TOWN OF VERNON
Planning & Zoning Commission (PZC)
Virtual Meeting Notice & Agenda **REVISED**
Thursday, October 1, 2020, 7:30 PM

SUBJECT: PZ-2020-10, 274 Talcottville Rd. Site Plan and Special Permits for the renovation of a Hair Salon

SUBJECT: PZ 2020-11, CT Golf Land, 95 Hartford Tpke.

Conceptual Site Plan

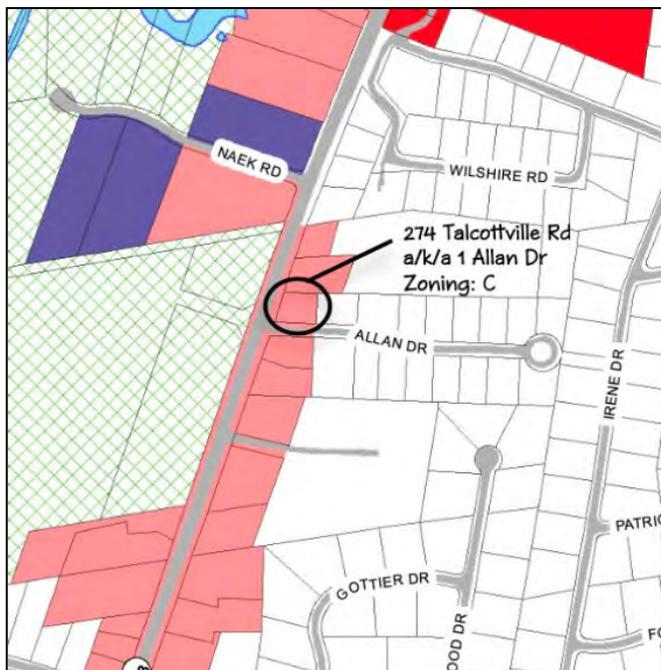
The Applicant intends to improve a previously established hair salon site through partial demolition and addition to the existing structure for a total size of +1,727 sq. ft. and plans to increase capacity to the salon stations as well as a new parking expansion from 8 to 19 spaces. Access to the site is via Allan Dr., where a new traffic light has recently been installed.

The Applicant received two setback variances (38' front and 39' side) from the Zoning Board of Appeals in February 2020 (ZBA 2020-02). The Site Plan meets the requirements of the Zoning Regulations and adds additional design elements, including a retaining wall and robust landscaping (arborvitae along the

The Applicant has attempted to address the corridor proximity with rear plantings and decorative fencing which appears an improvement over the existing condition.

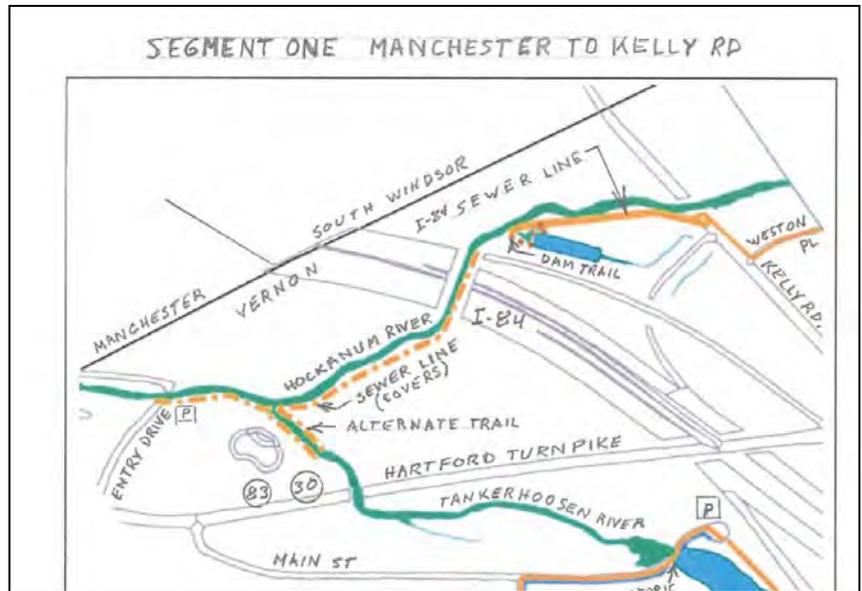
The Town Engineer is supportive of the added flood storage areas; the Zoning Official finds that the application and special permits are consistent with Town Regulations.

The Town Planner recommends additional landscaping, canopy trees, and perimeter fencing in the area of the two existing parking lots to better separate the parking both visually and functionally from the recreational facilities. The applicant does intend to preserve a great majority of the exiting perimeter landscaping, along with the removal of a few large trees adjacent to the proposed main building.
